Review of EIS and Vibration Impact Assessment for WestConnex M4 East

Independent Review

Prepared for Department of Planning and Environment | 19 January 2016

Report J15092RP1 | Prepared for Department of Planning and Environment | 19 January 2016

Figure 5 Site Plan and Sensitive Receivers Overview

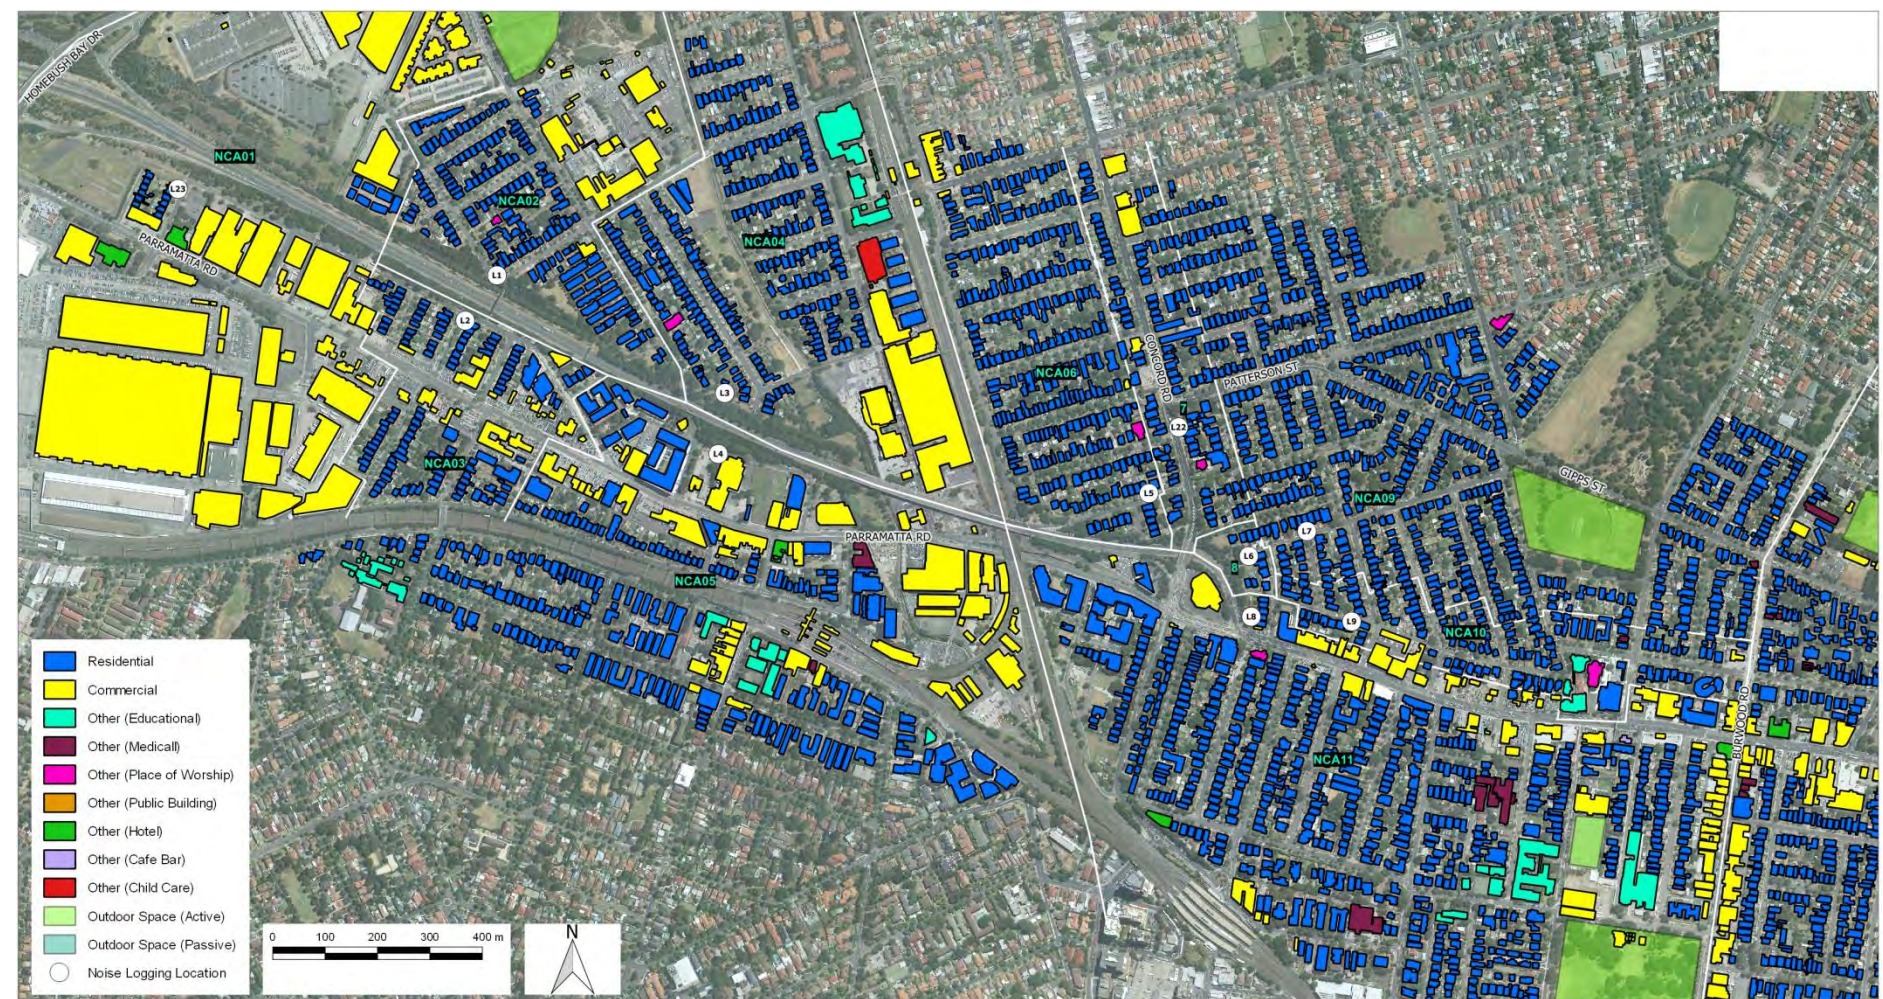
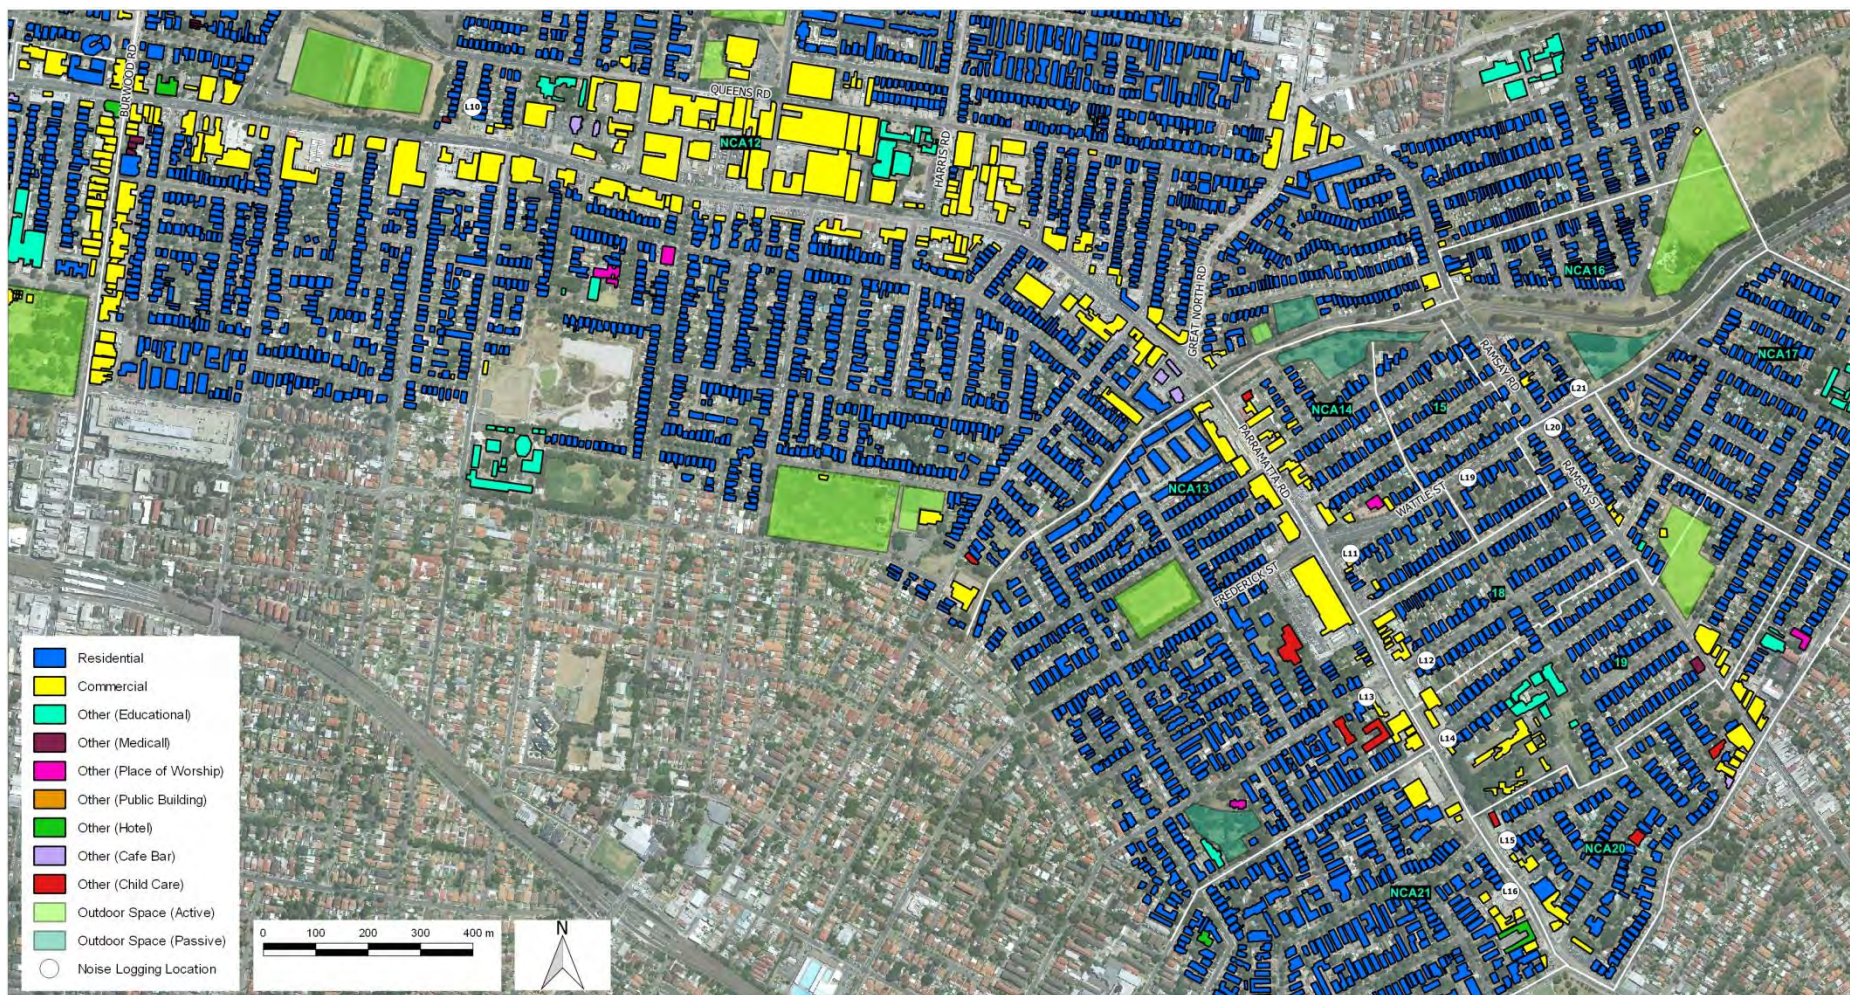
The adopted noise catchment areas (NCAs) are large and a single noise monitoring location is used within each NCA to represent the whole acoustic climate therein. The monitoring locations are used to serve two purposes. That is, to establish background noise for setting appropriate criteria for construction and fixed plant noise assessment, and to establish the existing level of traffic noise for assessment of future traffic noise impacts. Noise monitoring for these two purposes often has conflicting monitor positioning requirements. This could lead to shortcomings in the impact assessment of construction and fixed plant noise, as often the monitoring location is the closest to the main roadway nearby (eg existing M4 alignment) and not further away where background noise levels will be lower. While traffic noise reduces by 3 dB per doubling of distance and construction or fixed plant by 6 dB per doubling of distance, accounting for shielding due to barriers or buildings could lead to greater reductions of traffic noise at say beyond two rows of houses from the road. This level of attenuation is not necessarily the same for construction sites and fixed plant sources (which could be considerably elevated as per the ventilation building for example).

The adopted noise catchment areas (NCAs) are large and a single noise monitoring location is used within each NCA to represent the whole acoustic climate therein. The monitoring locations are used to serve two purposes. That is, to establish background noise for setting appropriate criteria for construction and fixed plant noise assessment, and to establish the existing level of traffic noise for assessment of future traffic noise impacts. Noise monitoring for these two purposes often has conflicting monitor positioning requirements. This could lead to shortcomings in the impact assessment of construction and fixed plant noise, as often the monitoring location is the closest to the main roadway nearby (eg existing M4 alignment) and not further away where background noise levels will be lower. While traffic noise reduces by 3 dB per doubling of distance and construction or fixed plant by 6 dB per doubling of distance, accounting for shielding due to barriers or buildings could lead to greater reductions of traffic noise at say beyond two rows of houses from the road. This level of attenuation is not necessarily the same for construction sites and fixed plant sources (which could be considerably elevated as per the ventilation building for example).

Figure 10 Noise barriers in the study area

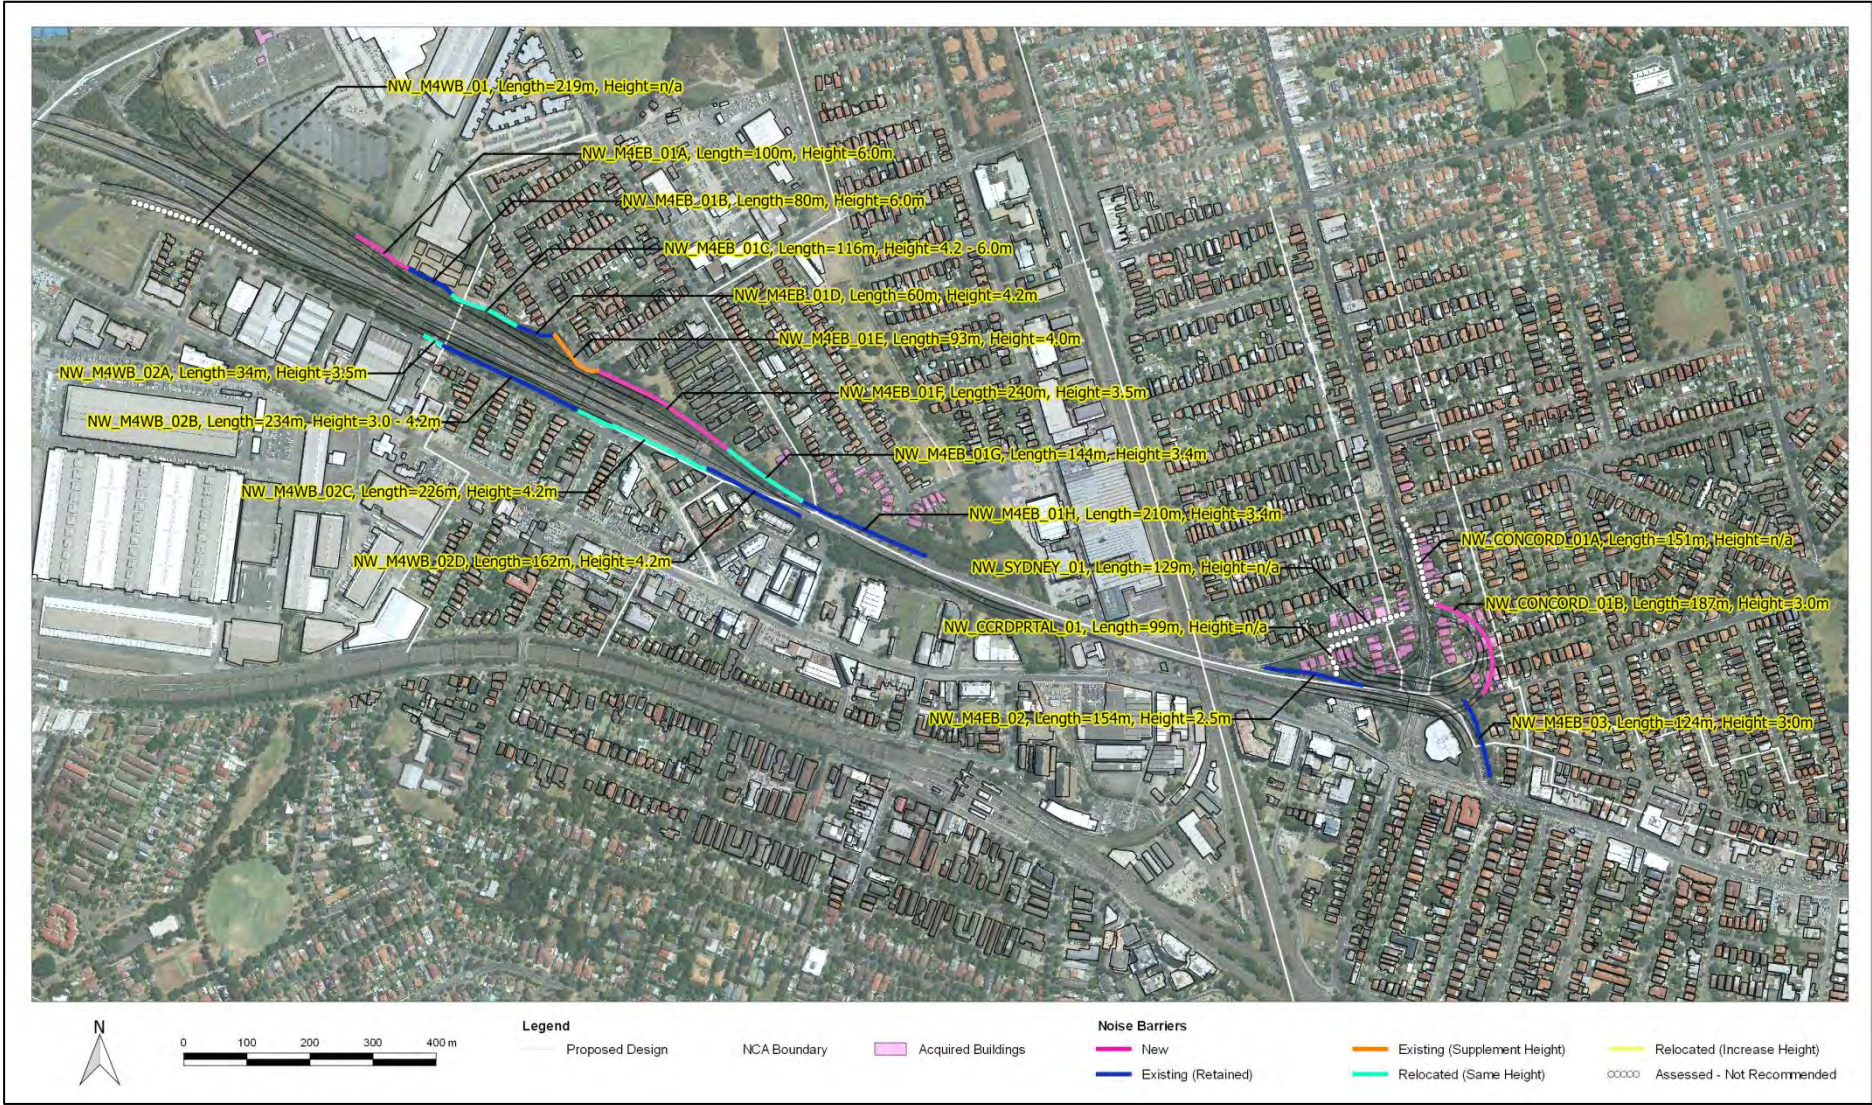
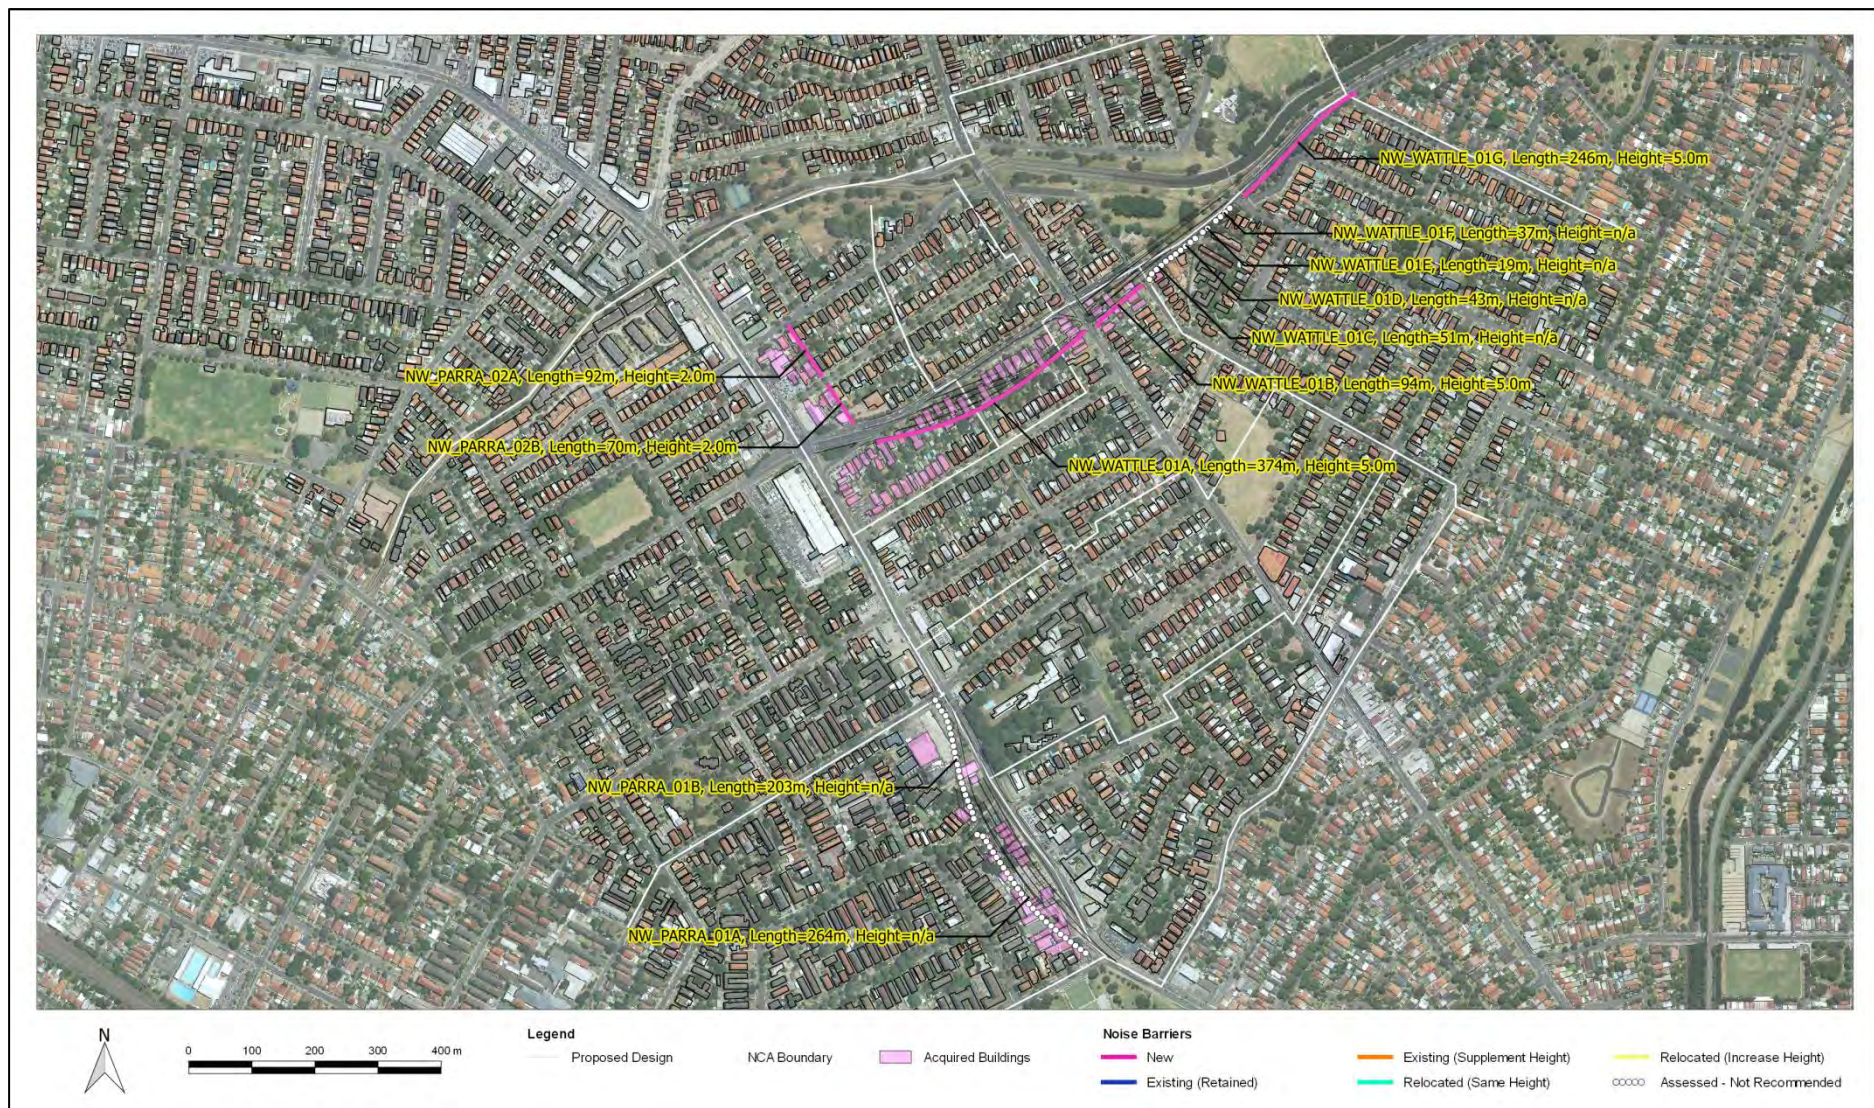
Figure 10 of the EIS NVIA shows the assessed road noise barriers (reproduced in Appendix B) with recommendations summarised in Table 19, reproduced below in Table 4.1. Recommended height is subject to further considerations during detailed design such as construction limitations, overshadowing, urban design and community preference.
